**Flood Control Project Maintenance
Levee Inspections**
LMA District Cover Sheet
Spring 2019 Levee Inspection Results

Levee District No. 0002 (Glenn County)

Levee Inspection Report By Mile - Spring 2019

Waterway	Bank	Unit Miles	Inspection Start/End	Inspector
Unit No. 01 Glenn County Sacramento River	Right	4.90	04/04/2019 04/04/2019	Makar Sokol

Photo 1 of 1 : SP_2019_LD0002_28_30_20190320_00014.jpg

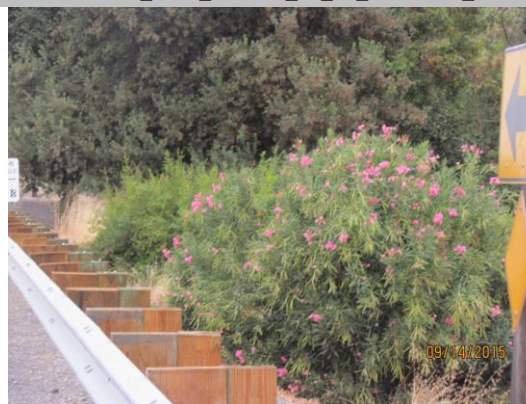
LM Start	1.03	Rating **	M	Issue No.	30
LM End	1.03	Issue Type +	En	Location *	WS
Category	Earthen Levee			GPS Latitude/Longitude	
				Start	End
Item	Vegetation			39.428445 °	39.428445 °
				-122.010972 °	-122.010972 °
DWR ID	DWR_LD0002_01_f_2015_30				
Comment Code					
V6 : Landscaping					
Inspector Comment					
Remove the oleanders from the waterside slope.
